Applicant: Kazutaka Inukai Attorney's Docket No.: 12732-201001 / US6877

Serial No.: 10/743,344

## Amendments to the Drawings

## REMARKS

[FIG. 3] PRIOR ART

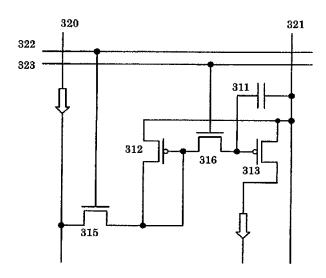
In Figure 3, the legend, "PRIOR ART" has been added.

The Examiner states that Fig. 3 should be designated as "PRIOR ART." In reply to this objection, Fig. 3 has been amended to add the legend "PRIOR ART." In addition, Figs. 1, 2, 4 and 5 have been amended to properly label them as Figs. 1A-1E, 2A-2D, 4A and 4B, and 5A-5H.
